OPERATION REPORT
FEDERAL ENERGY REGULATORY COMMISSION
OFFICE OF ENERGY PROJECTS
DIVISION OF DAM SAFETY AND INSPECTIONS
CHICAGO REGIONAL OFFICE

For the period October 23, 2003 to September 30, 2004

Licensee Ameren UE Project No. 2277

Project Name Taum Sauk NATDAM Nos. MO30040 and MO30041

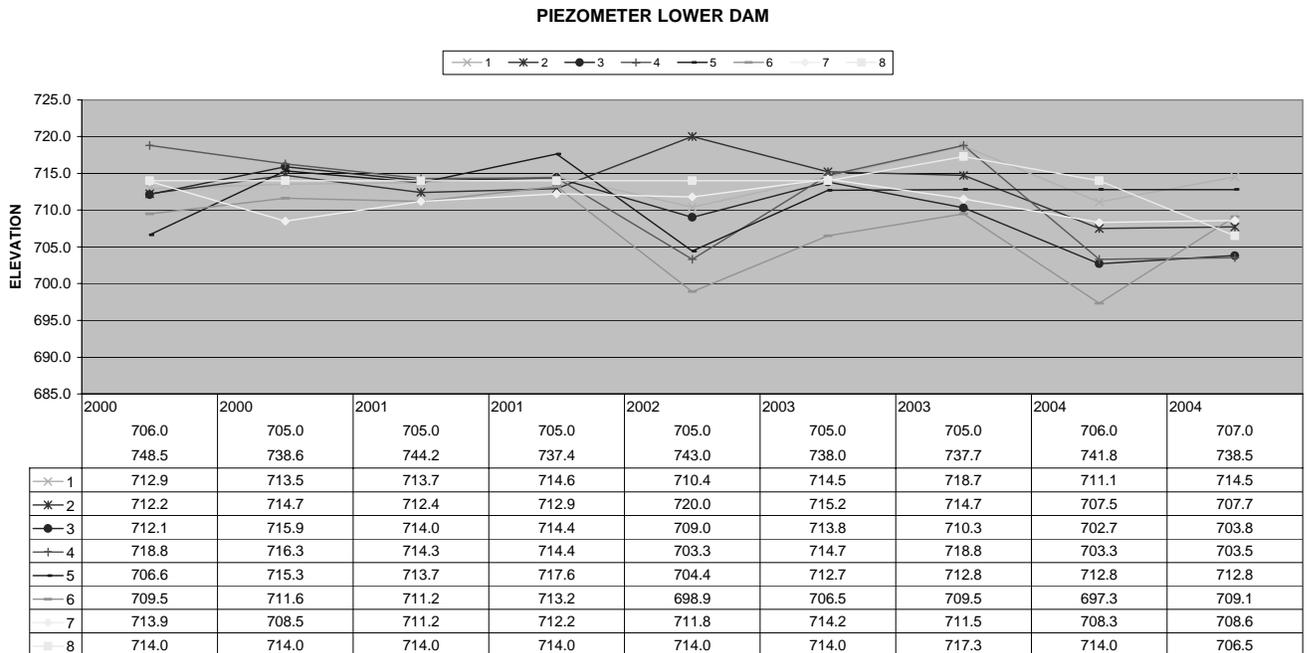
The licensee also maintains eight piezometers in the gallery of the lower dam and monitors them twice a year. We reviewed piezometer readings for the past several years during this inspection, and found uplift pressures to fall within normal ranges (see graph below).
